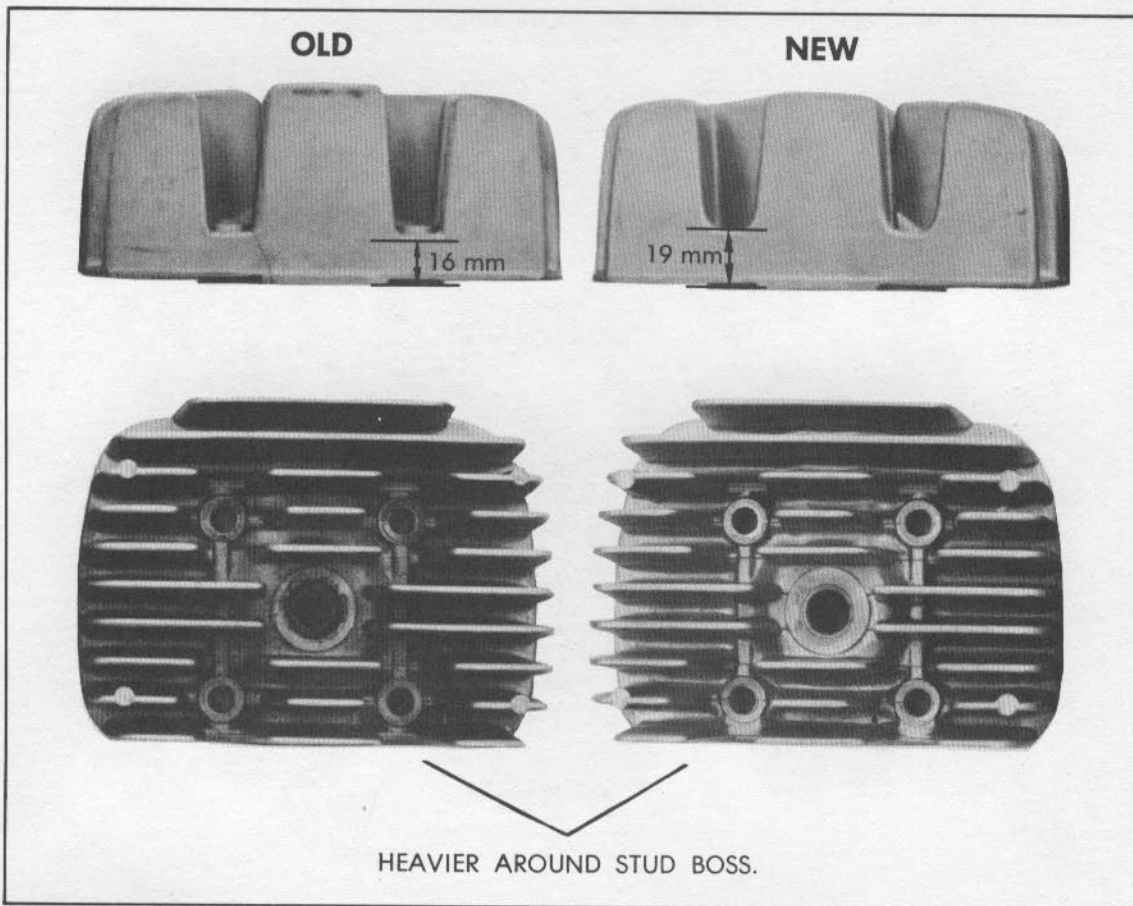
On some early S2 machines, there is a slight possibility of the cylinder heads cracking as shown below. Our experience indicates that the fault may occur under conditions of hard usage, such as extended full throttle operation for long periods of time.

With a cracked cylinder head, there is a slight power loss in the high RPM range in 4th and 5th gear. On some units the engine may detonate because fuel/air mixtures are upset from leakage. Generally, a cracked head will not be visually noticeable unless the head is removed from the engine.

All replacement cylinder heads in parts stock are thicker to prevent this problem; the part number is unchanged. The differences are illustrated below for identification purposes. A cracked head should be replaced immediately. Although all three heads need not be changed, they should be inspected for cracks and retorqued to 18 lb.-ft.

The new thicker cylinder heads have been installed in production from engine number S2E-07595.
